Re: WWDL for Passage West Monkstown Ref. No. D0129-01.
Response to Notice in accordance with Regulation 18(3)(b) of the
Waste Water Discharge (Authorisation) Regulations 2007.

REGULATION 18 3(b) RESPONSE

WASTE WATER DISCHARGE LICENCE APPLICATION

PASSAGE WEST/MONKSTOWN

Designed:	Checked:	Scale:	Drawing No.
BOL	BQ	1:5,000	Map 15
Drawn:	Approved:	Date:	Revision 1
BOL	BQ	23/06/09

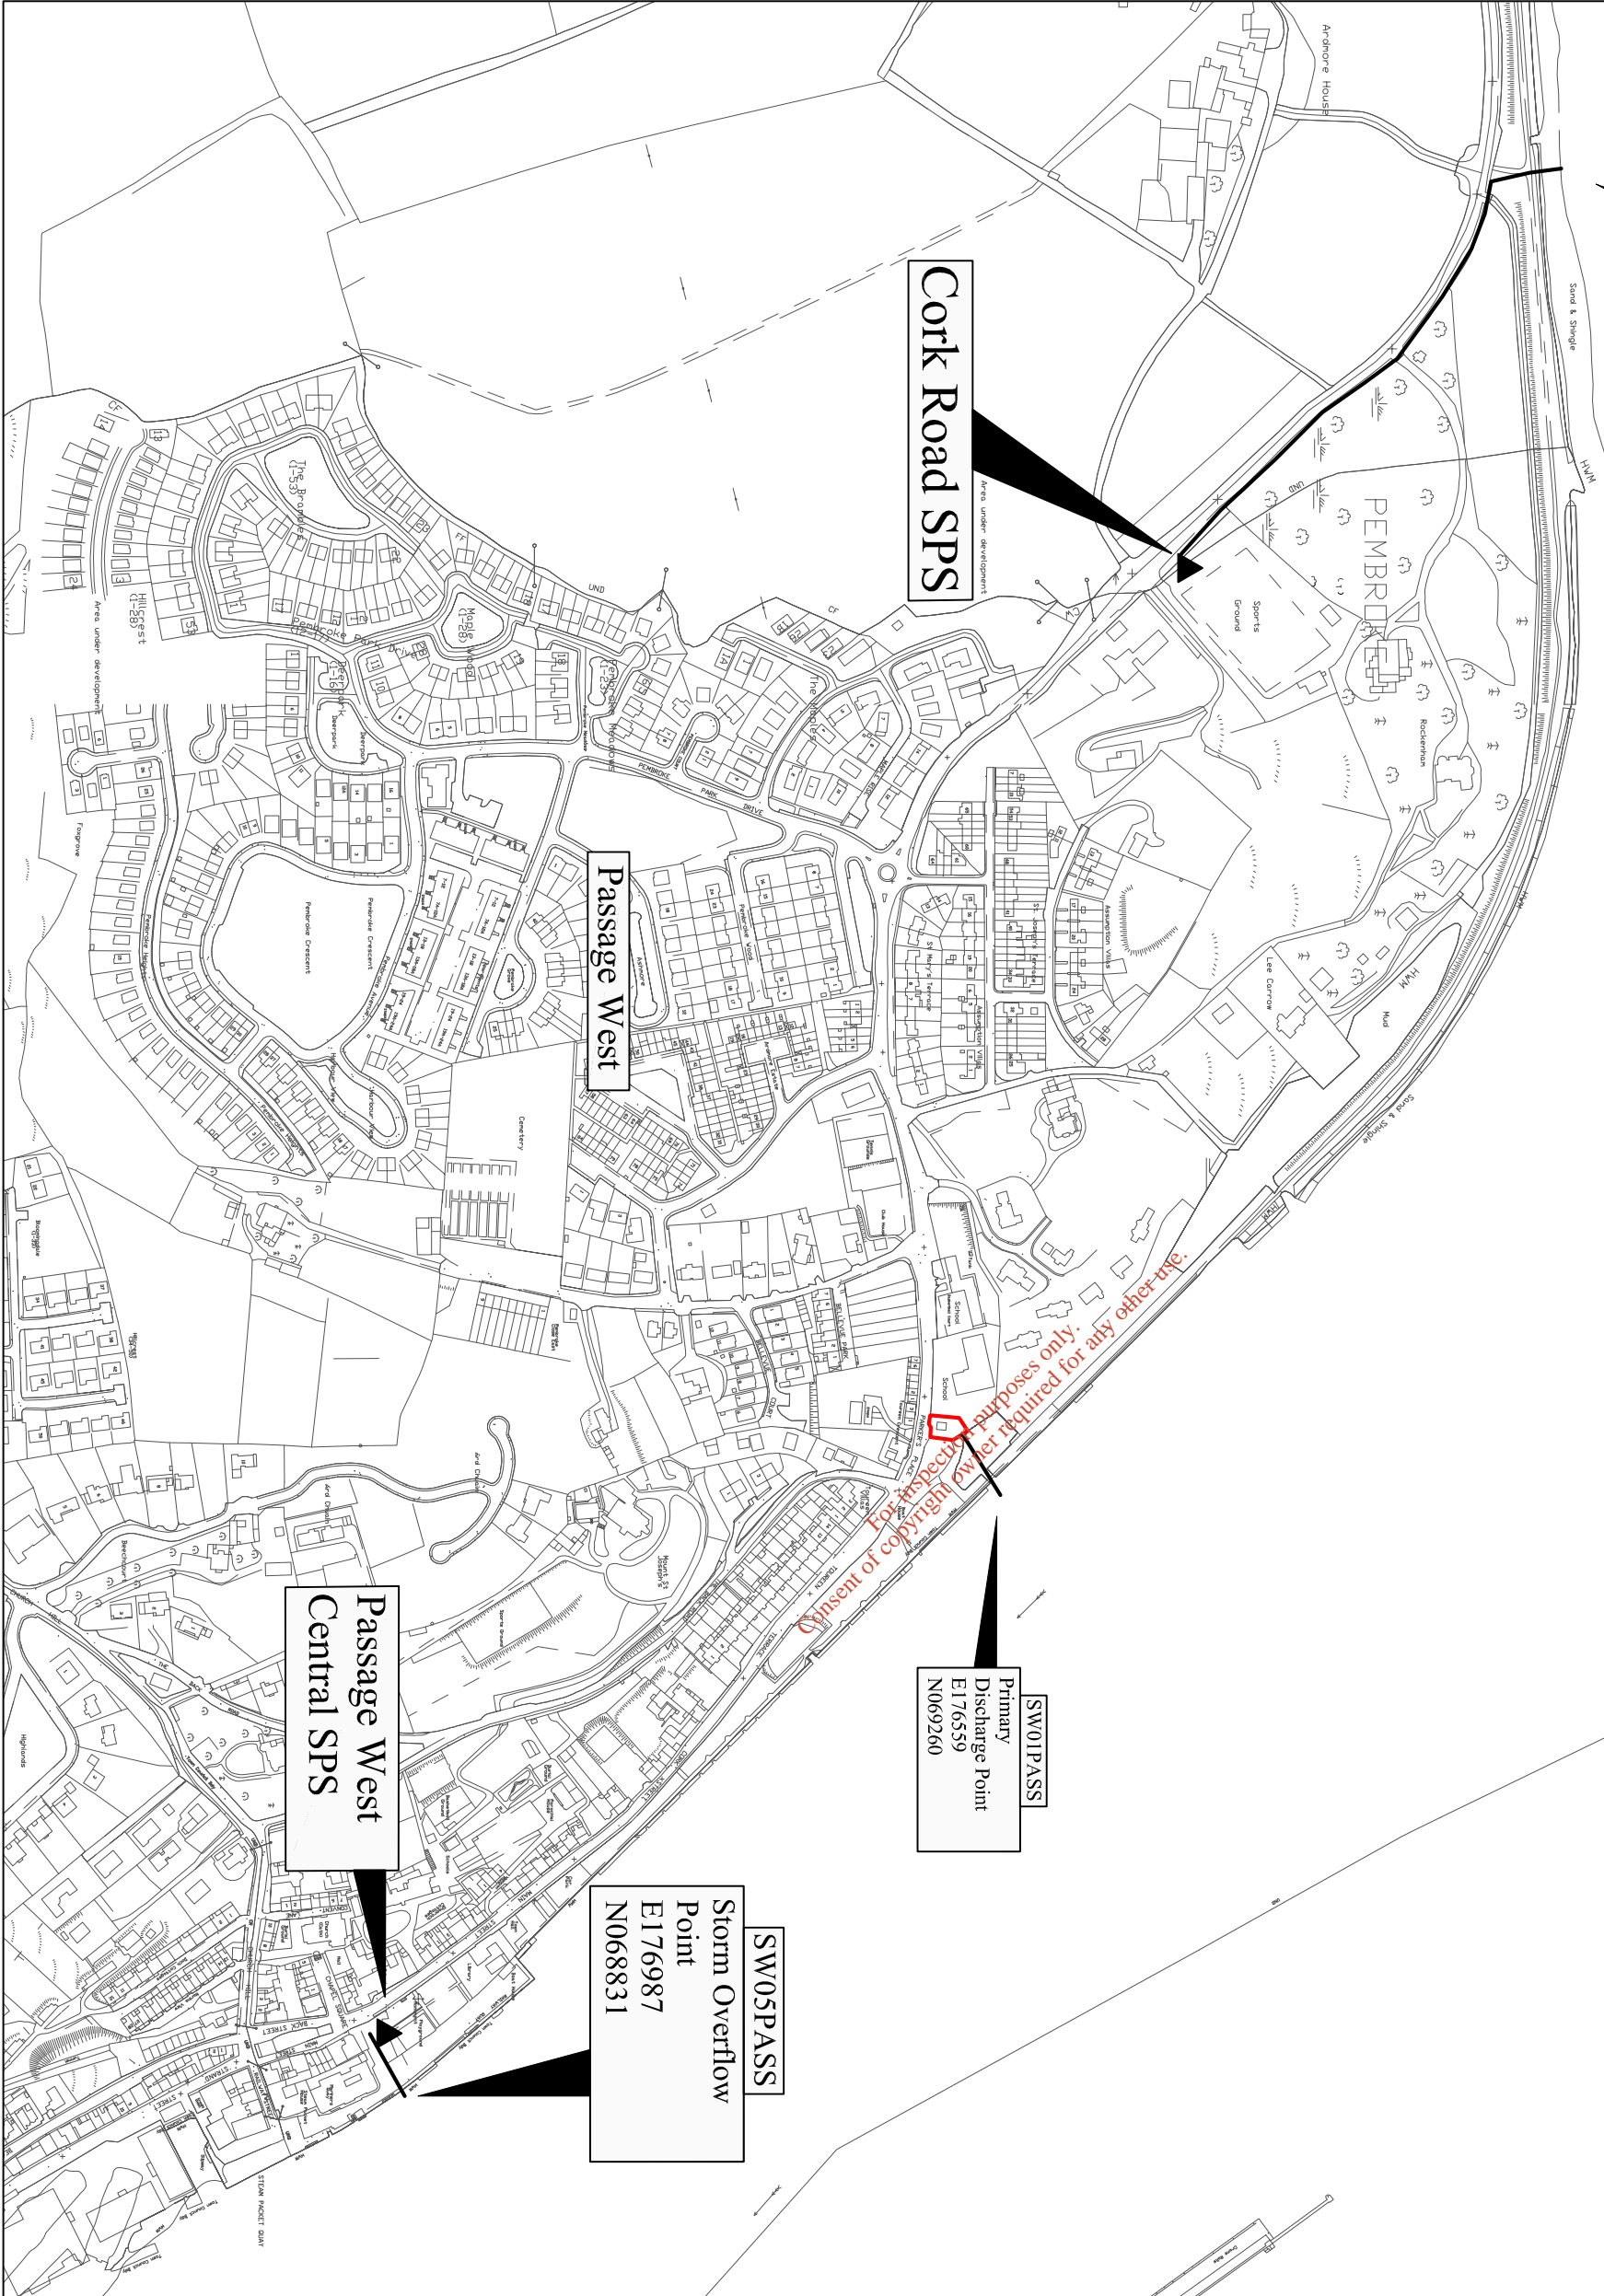
With reference to EPA's WWD Application Guidance Notes, please re-evaluate the discharge and overflow points in the agglomeration. In particular please note that each primary and secondary discharge from a wastewater works will be the subject of Emission Limit Values aimed at ensuring Environmental Quality Standards. Also please detail all Storm Water Overflows in the agglomeration, including those, which do not meet the relevant assessment criteria.

Discharge points (SW04 – SW08) can be utilised as storm water overflows during intense rainfall periods to relieve the network. In response to request for further information, secondary discharge points SW04 – SW08 have now been recognised also as Storm Water Overflow points and this additional information has been added in this document for consideration and in the revised application attached.

Storm water overflow points, SW04 – SW08 are detailed in Section B.5. of the revised WWDL application attached and on new maps (Map 15 Revision 1, Map 16 Revision 1, and Map 17 Revision 1) included. There is no data available regarding the frequency or volume of flow emitted through the storm water overflow points. Compliance with DoEHLG 'Procedures and Criteria In Relation to Storm Water Overflows' cannot be determined for the current system due to insufficient data.
